PLANNING & ZONING CASE NO. SP2024-031

ADDRESS	Northeast corner of Data Drive and Springer Road				
SUBDIVISION	Rockwall Technology Park Phase V	LOT	Part of 1	BLOCK	B
GENERAL LOCATION	Northeast corner of Data Drive and Springer Road

SITE PLAN EXHIBIT
ROCKWALL TECHNOLOGY PARK PHASE V
PART OF LOT 2, BLOCK B

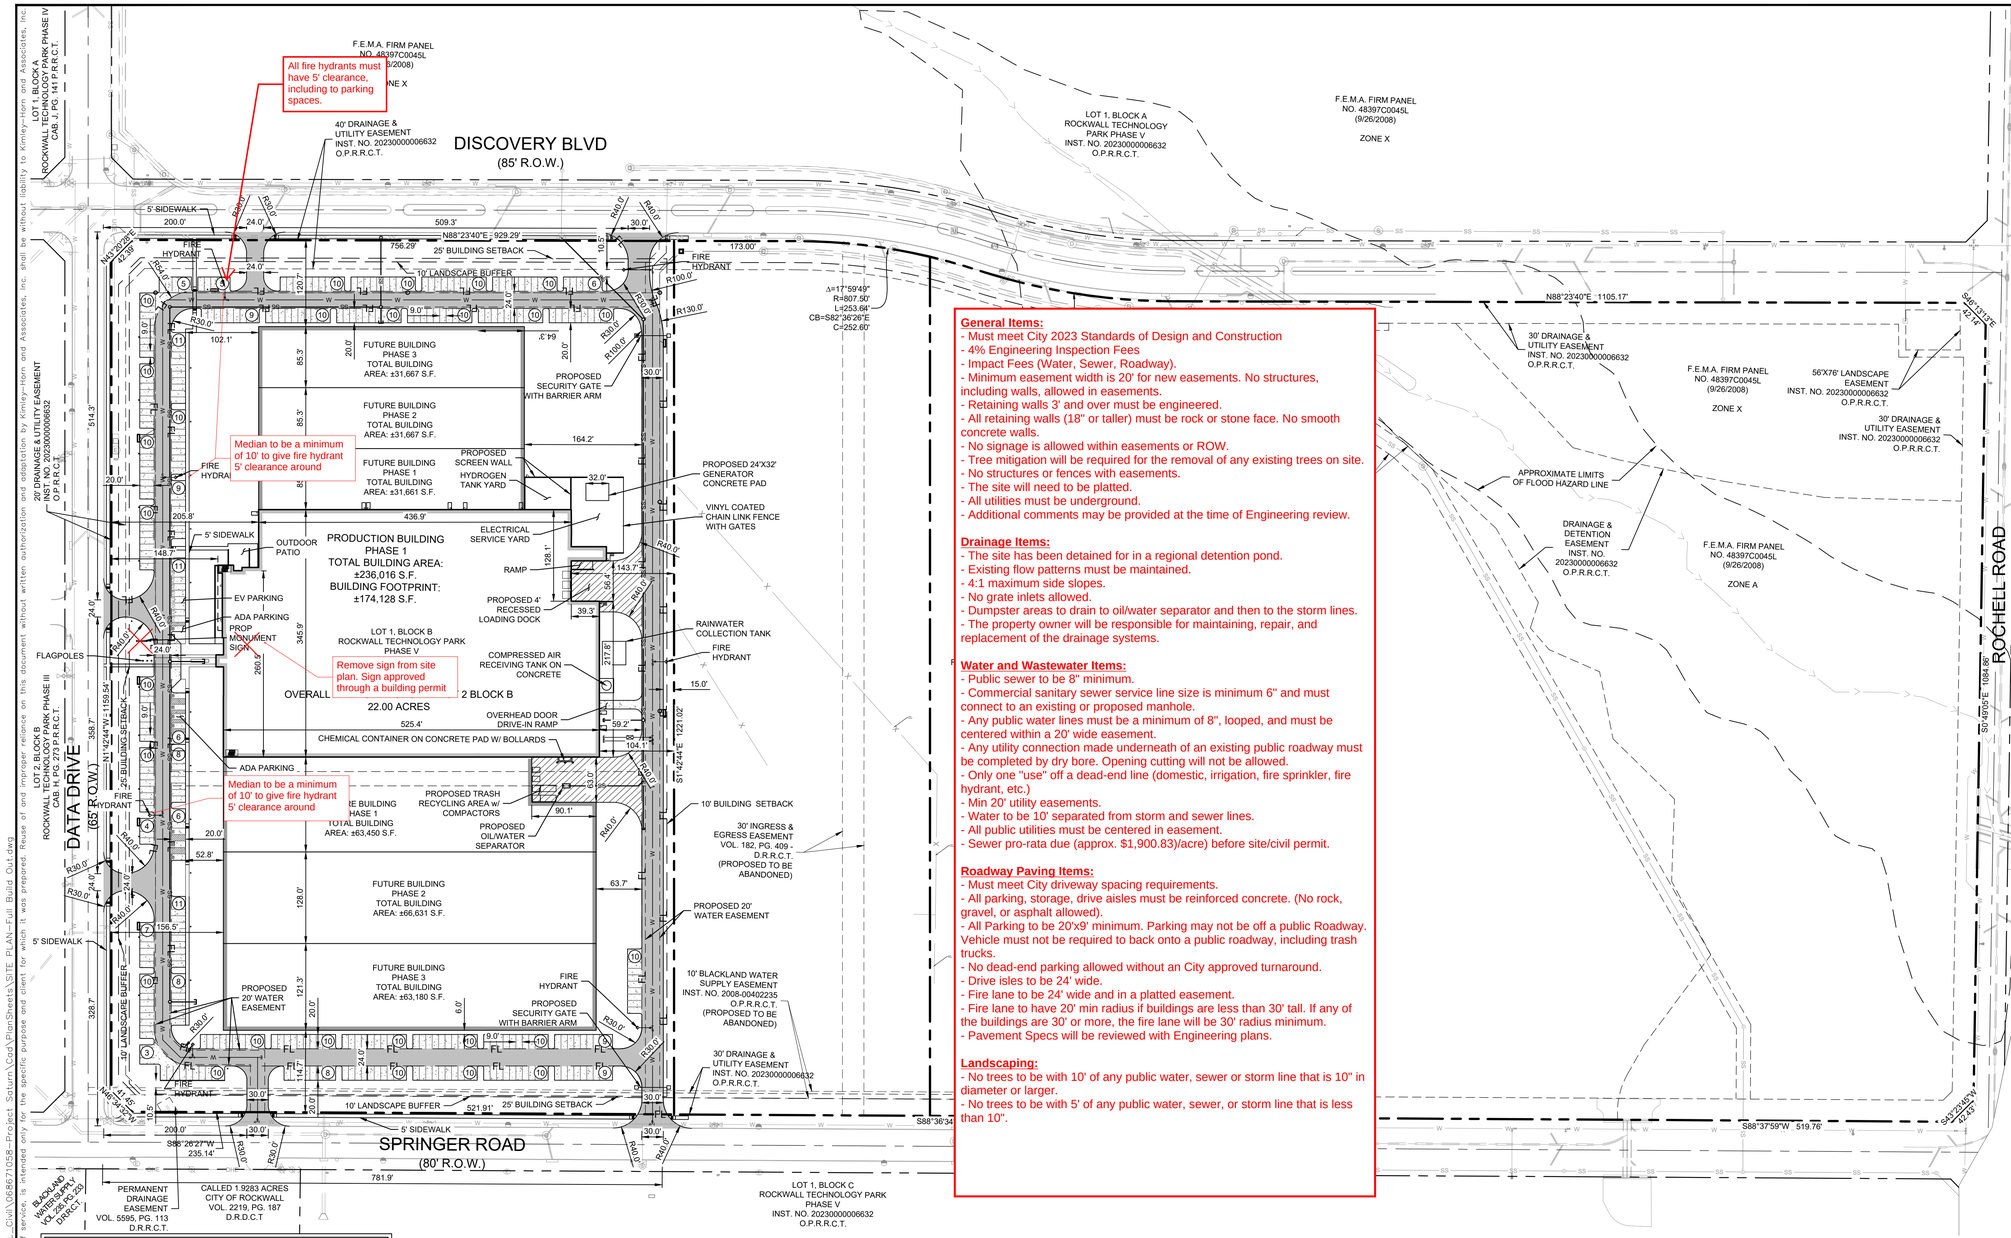
General Items:
- Must meet City 2023 Standards of Design and Construction
- 4% Engineering Inspection Fees
- Impact Fees (Water, Sewer, Roadway).
- Minimum easement width is 20' for new easements. No structures, including walls, allowed in easements.
- Retaining walls 3' and over must be engineered.
- All retaining walls (18" or taller) must be rock or stone face. No smooth concrete walls.
- No signage is allowed within easements or ROW.
- Tree mitigation will be required for the removal of any existing trees on site.
- No structures or fences with easements.
- The site will need to be platted.
- All utilities must be underground.
- Additional comments may be provided at the time of Engineering review.

SHEET NUMBER
L2.04

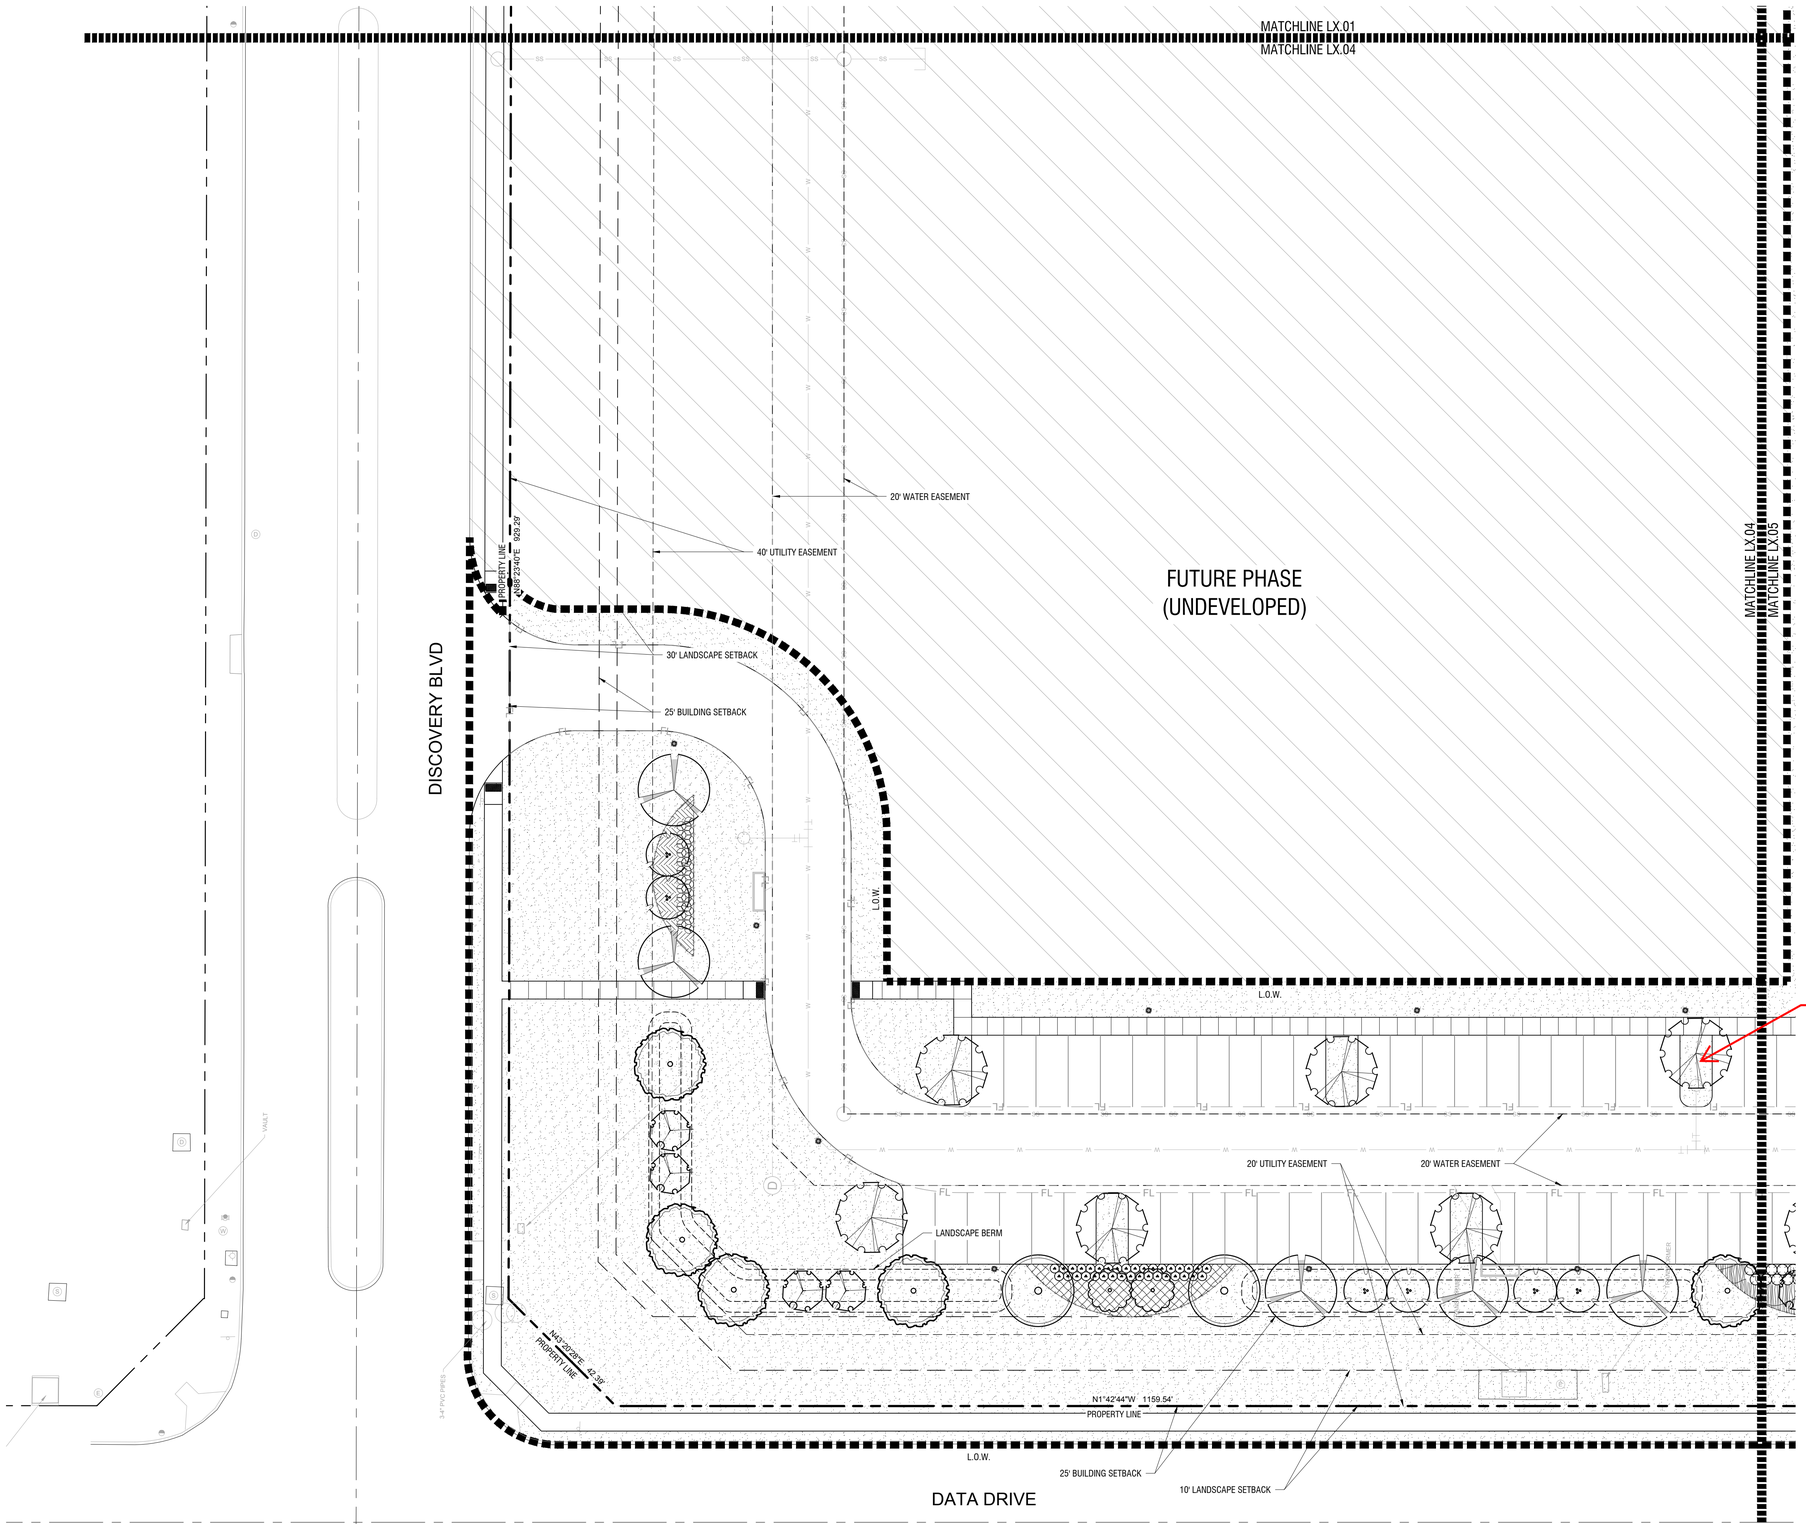
No trees to be with 10' of any public water, sewer or storm line that is 10" in diameter or larger. No trees to be with 5' of any public water, sewer, or storm line that is less than 10".
